UNITED STATES PATENT AND TRADEMARK OFFICE

APPLICATION NO.	FILING DATE	FIRST NAMED INVENTOR	ATTORNEY DOCKET NO.	CONFIRMATION NO.
09/832,892	04/12/2001	Takehisa Yamaguchi	205975US2	1675

Office Action Summary

DETAILED ACTION

第 1 図

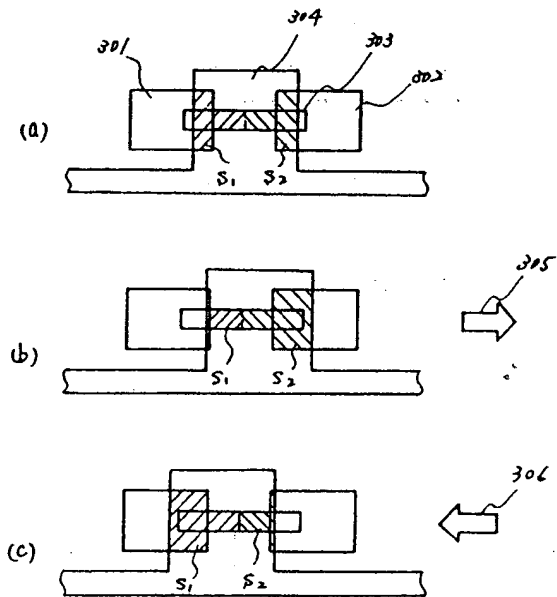
Takashi teaches (Fig. 1) a liquid crystal display comprising:

- a gate electrode line 106 including a gate electrode formed on an insulating substrate;
- a source electrode line 108 including a source electrode 103 intersected with said gate electrode line 106 via an insulating film (gate insulating film 105);
- a thin film transistor including said gate electrode, said source electrode, and two drain electrodes located in a vicinity of a portion in which said gate electrode line is intersected with said source electrode line;
- two drain electrode lines 102, each including a portion acting as one of the two drain electrodes, said two drain electrode lines being connected with a pixel electrode 107;

- said two drain electrodes are located on opposite sides of said source electrode with each of said two drain electrodes having a near side opposed to said source electrode that is superposed with said gate electrode and a far side opposed to near side that is not superposed with said gate electrode.
- an area of a region where said gate electrode line 106 is superposed with the near side of one of said two drain electrodes is substantially identical to an area

of a region where said gate electrode is superposed with the other one of said two drain electrodes as shown in Fig. 1b according to claim 2.

- a length of a region in a channel lengthwise direction of said thin film transistor where said gate electrode is superposed with the near side of one of said two drain electrodes is substantially identical to a length 109 of a region in a channel lengthwise direction of said thin film transistor where said gate electrode line is superposed with the near side of other one of said two drain electrodes according to claim 3,
- said two drain electrodes are formed in whole part of one end of said drain electrode line in a channel widthwise direction where the near side of each drain electrode is superposed with said gate electrode line according to claim 5;

Takaski discloses drain electrodes having the near sides thereof facing a source electrode superimposed over a gate electrode with the far sides of each drain electrode opposed to the near side not being superimposed over the gate electrode and being connected to pixel electrode (see attachment).
